# SERVICE INFORMATION LETTER

SIL # 170901-345943WE

**SUBJECT:** The Wencor Packing PN 345943WE was incorrectly manufactured with extra chamfers on the inner diameter corners as shown in Figure 1 below.

**Figure 1, View Showing Extra Chamfer on Packing**

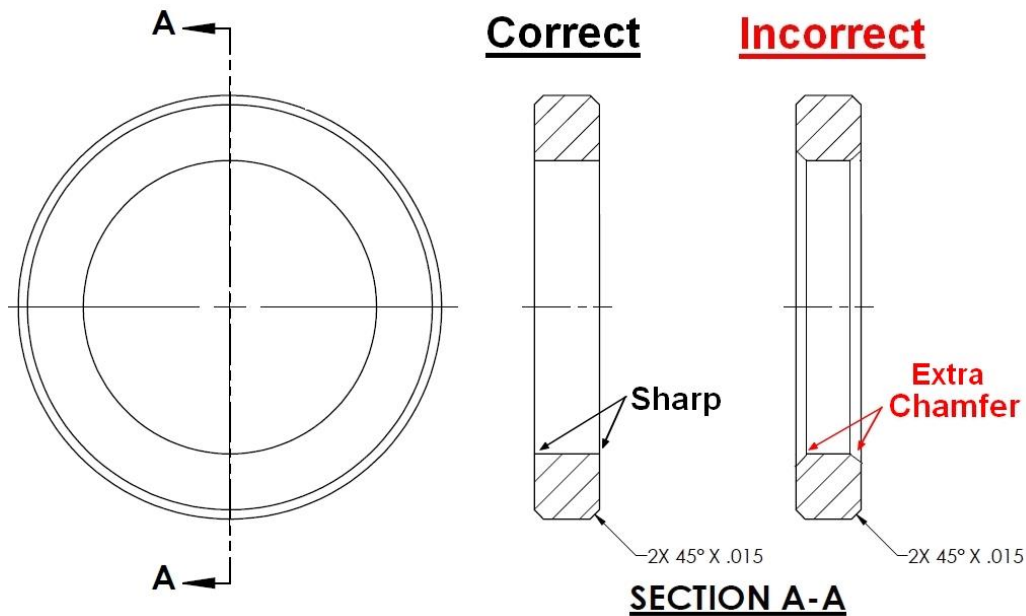
Some Packing's were incorrectly manufactured with extra chamfers on the inner diameter corners as shown below.

Wencor Packing PN 345943WE sold to customers between March 2016 and July 2017 are affected by this SIL. Any Packing's from this time period that have the condition described above that have not been installed may be returned to Wencor at the discretion of the end user for replacement or credit.

Wencor Packing's PN 345943WE sold during this time period that have the condition described above that have been installed into the NHA unit and passed the required CMM testing may remain in service without any appreciable risk to normal unit operation.

**Figure 2, Packing Installed Locations into the NHA**

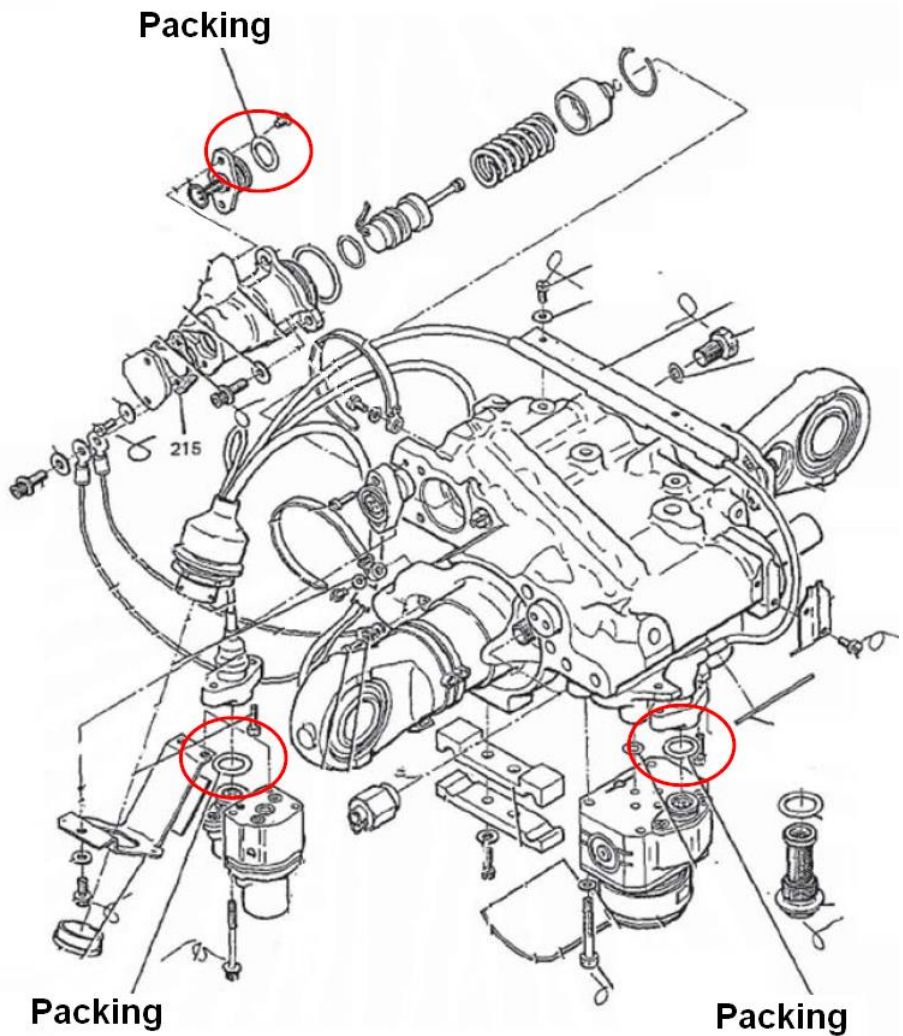
The Packing's are installed at various static interface locations between the aileron actuator housing and attached components as shown in Figure 2 below. The packings are not used in high pressure hydraulic fluid lines, but serve only as a barrier from external elements such as dust, water and external leaking hydraulic fluid.
